PROJECT TITLE: Discount Tire Co. ZONE ATLAS/DRNG. FILE #: J-21/D 40A 27LEGAL DESCRIPTION: Tract A-Z, Block 39 B, Princess Jeanne Park.CITY ADDRESS: 1119 Juan Tabo Blvd.ENGINEERING FIRM: Lovelady & Assoc. CONTACT: Frank LoveladyADDRESS: 7408 Morrow Ave. NE 87110 PHONE: 883-7973

RE: REVISED DRAINAGE PLAN FOR DISCOUNT TIRE COMPANY
(J-21/DI6A) RECEIVED JUNE 2, 1987
27

RE: DRAINAGE COMPLAINT @ DISCOUNT TIRE (J-21/D²⁷16A)

GRADING AND DRAINAGE PLAN
DISCOUNT TIRE COMPANY
1119 JUAN TABO BLVD., N.E.
ALBUQUERQUE, NEW MEXICO

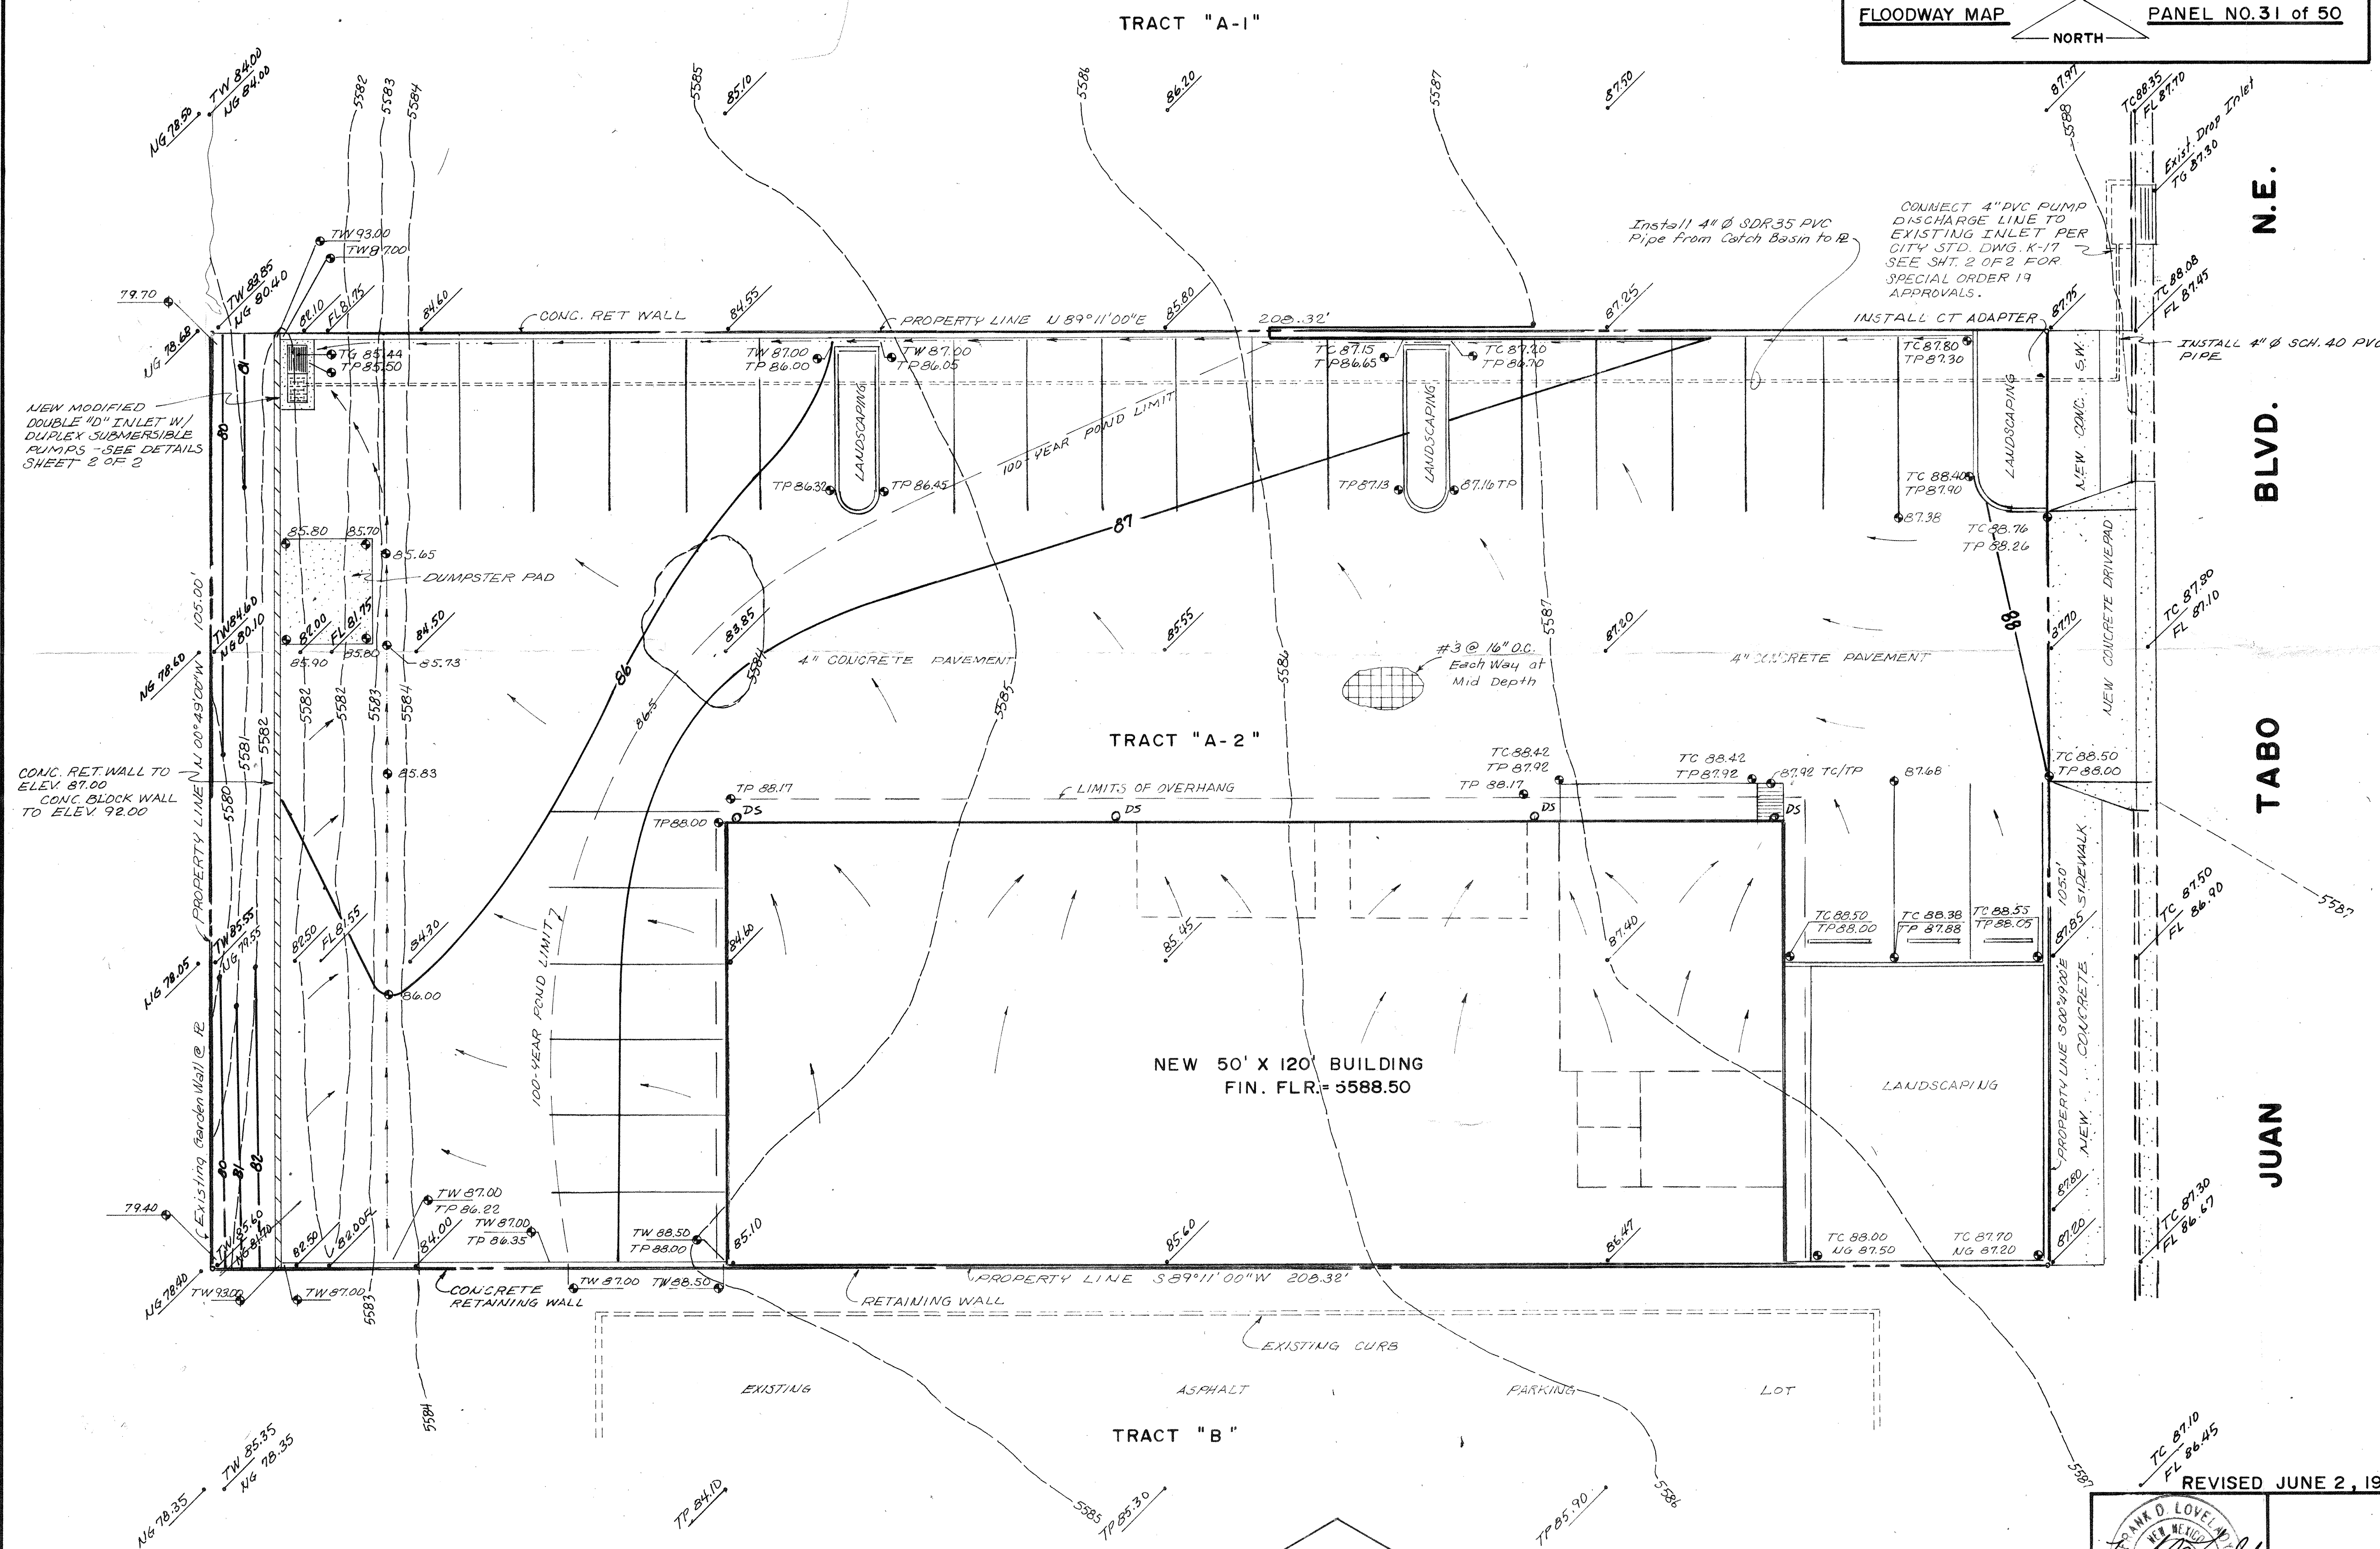
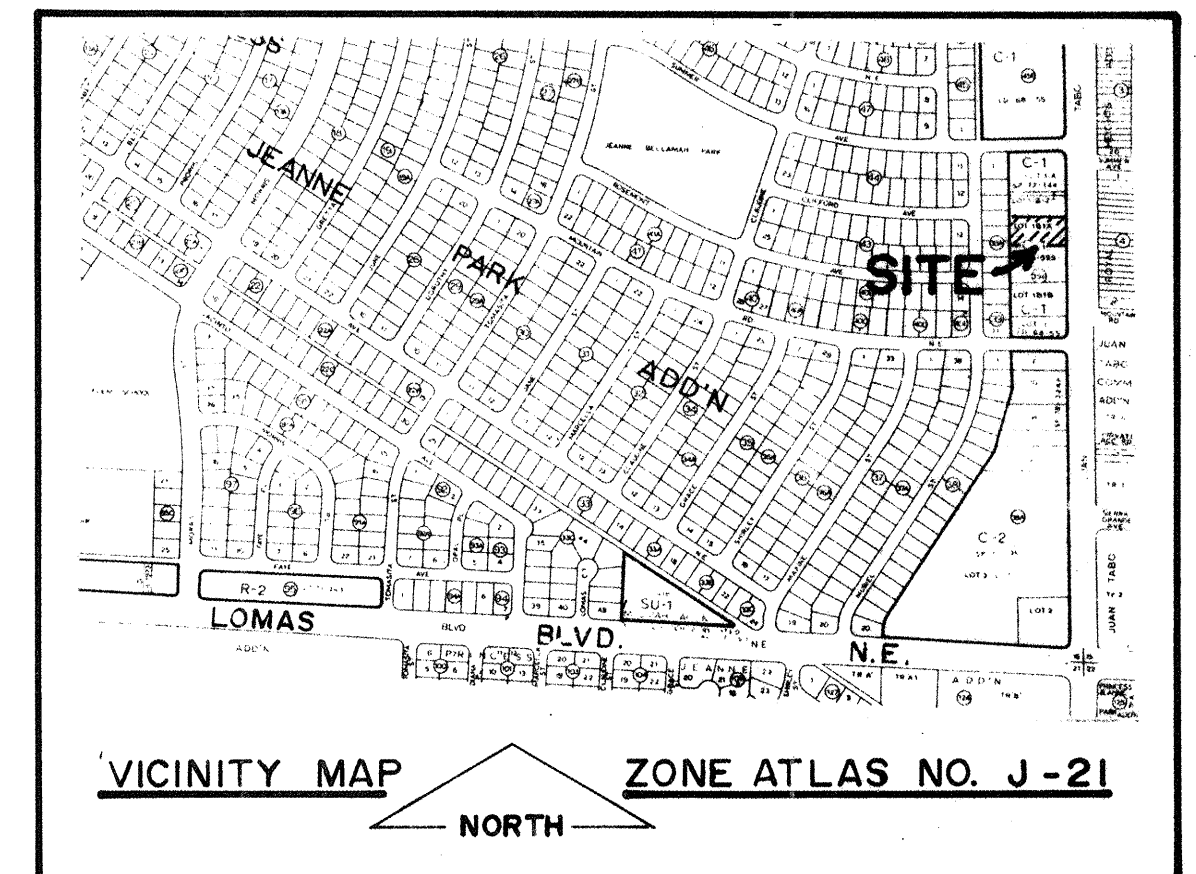
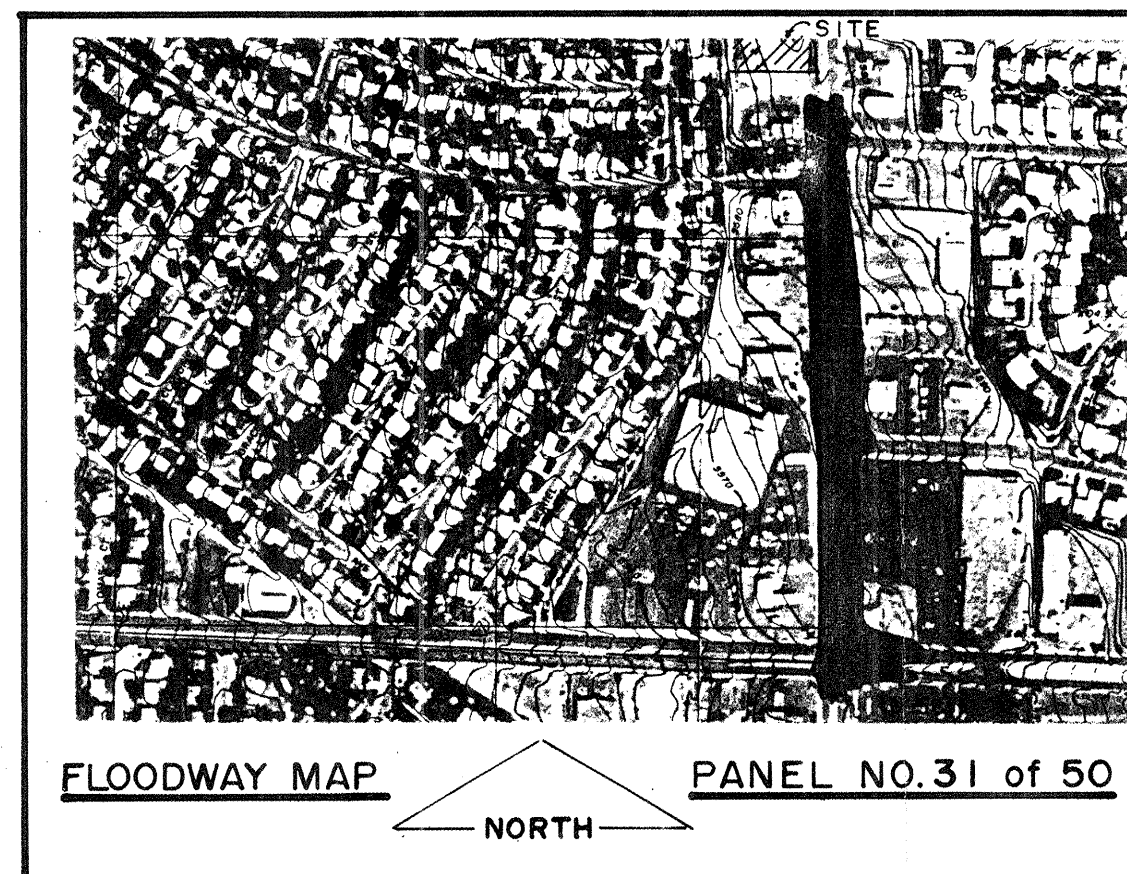
On June 5, 1987, this office approved your drainage plan for the referenced Building Permit. Sheet 2 of 2 on your drainage plan indicated that "There is no off-site flows affecting this site." However, we have received a drainage complaint and we have field verified the damage caused by flows which were blocked by your development. Prior construction of your development, historic runoff would cross your property from north to south. Your development has blocked these historic off-site flows. Therefore, due to this diversion, the historic flows traveled west across private property.

As the flows traveled west, it collapsed a garden wall and caused other damage. We believe that your drainage plan misrepresented the existing conditions. Also, this site is responsible to accept the historic off-site flows. I would appreciate your immediate attention due to possible future damage which will occur if we receive a substantial storm.

A Grading and Drainage plan for the referenced site was approved June 5, 1987. According to this plan, minimum fill was to be placed against the wall along the west property line.

Due to the collapse of the garden wall located at the northwest property corner, an inspection was made. The inspection revealed that fill had been placed against the wall, which has caused damage.

If fill material is going to be placed on your west property line, a retaining wall is required. Should the garden wall fail as a result of excess fill, your store may be liable for any damages caused to adjacent properties.

We have received a drainage complaint from the owner of the resident at your west property line. The block wall between the two properties has collapsed. A field inspection indicated that excessive fill has been placed against the block wall. The wall is not a retaining wall. Also, your south wall shows stains on the concrete that indicates that site runoff has traveled south to the collapsed wall. Please contact this office within two weeks to discuss what corrective measures are to be taken.

We have received a drainage complaint from the adjoining west property owner. A field visit and a review of the approved drainage plan showed two problems.

1. We found that there was not a sump pump to convey the site runoff to Juan Tabo. A pump needs to be installed.
2. The drainage plan shows a maximum of 1.5 feet of fill against the west garden wall. However, in the field there is more fill placed against the garden wall.

Further investigation on September 16, 1991, has revealed that the pump which is supposed to be located within the inlet of the Discount Tire Store is not installed. Without the pump to pump the water out to Juan Tabo, the runoff went to the west causing the erosion along Mr. Burright's wall.
